**ADDENDUM NUMBER ONE**

**CHARLES A. BELL PARK**

**ENGINEER:** BARGE, WAGGONER, SUMNER & CANNON, INC.  
1110 Market Street  
Chattanooga, Tennessee 37402

**ADD. NO. 1 ISSUED DATE:** October 14, 2016

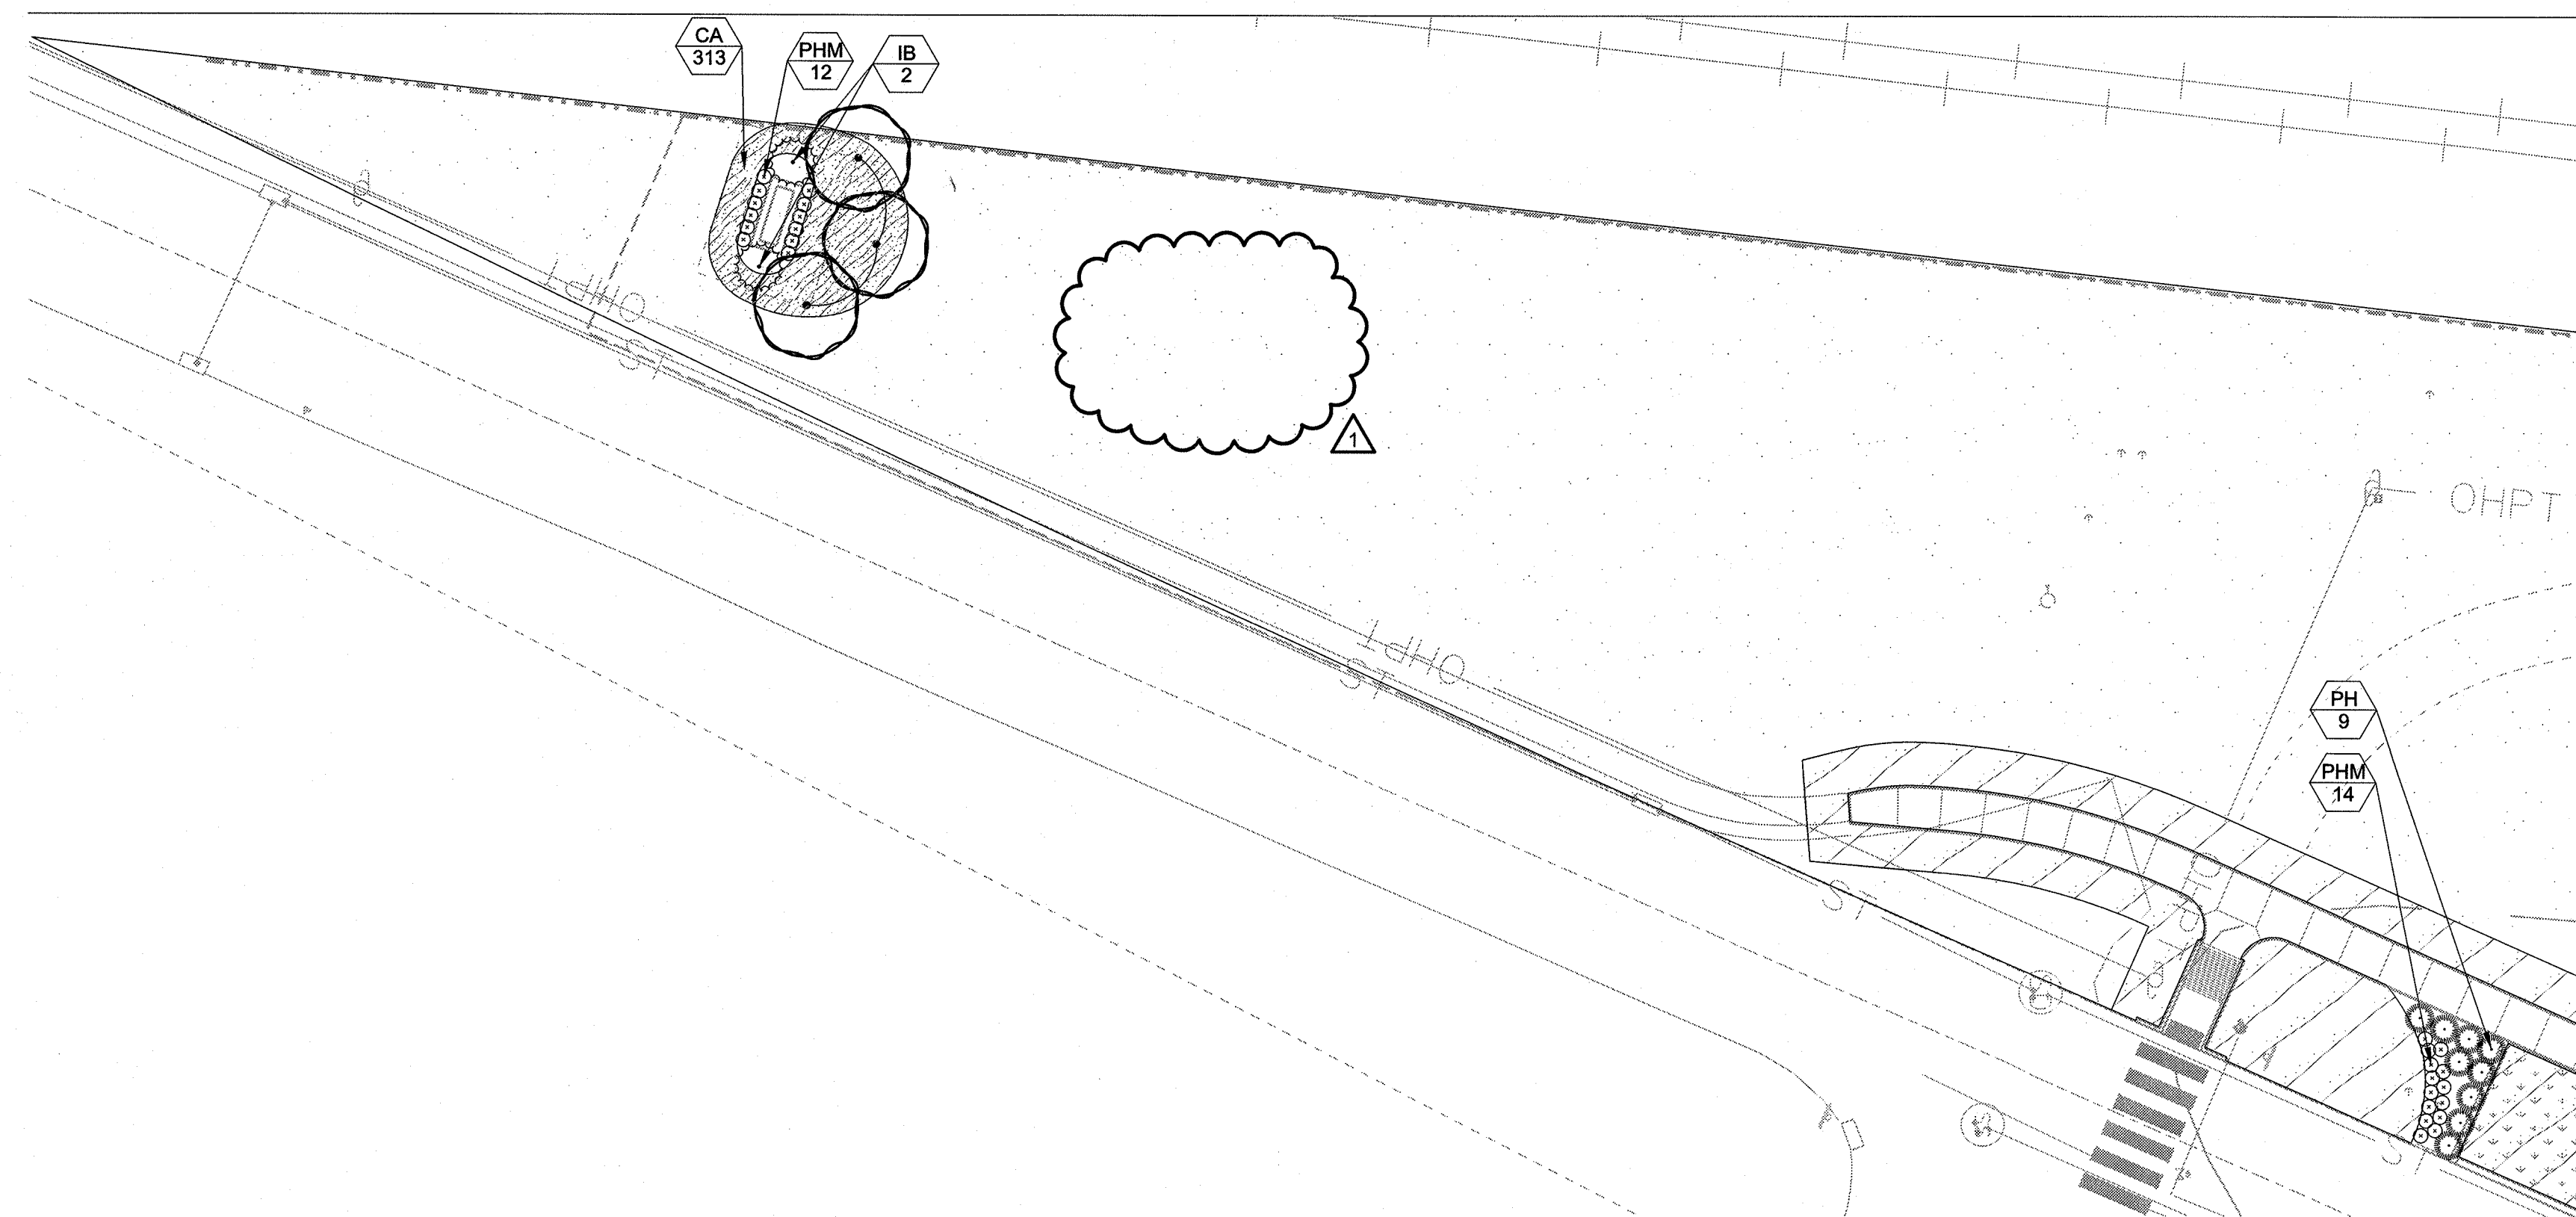
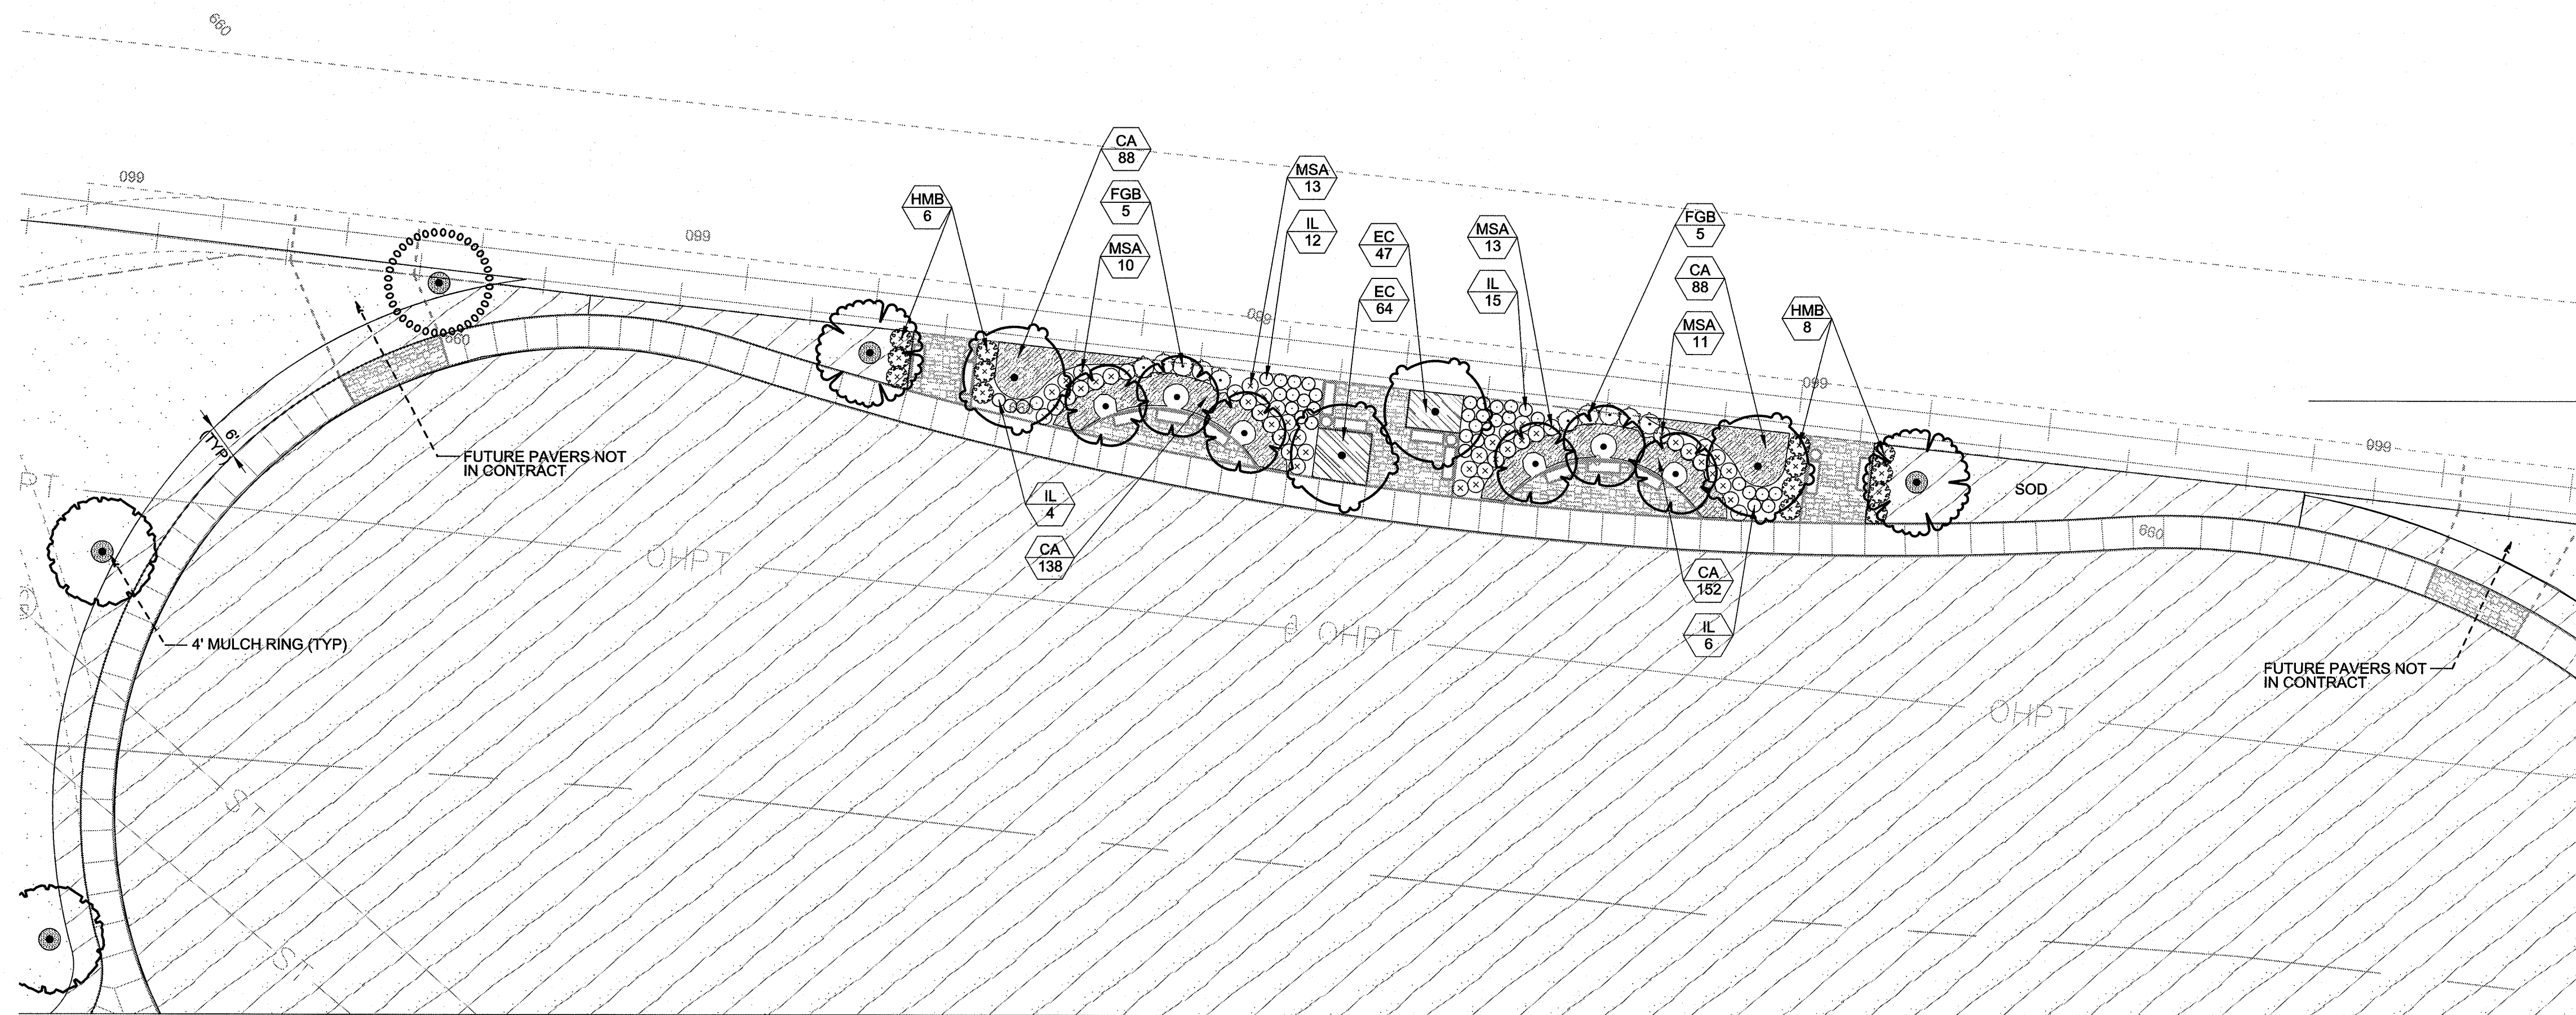
ITEM C2: Sheet L1.01: Revised overall Landscape Plan.

ITEM C3: Sheet L1.02: Revised Landscape Plan
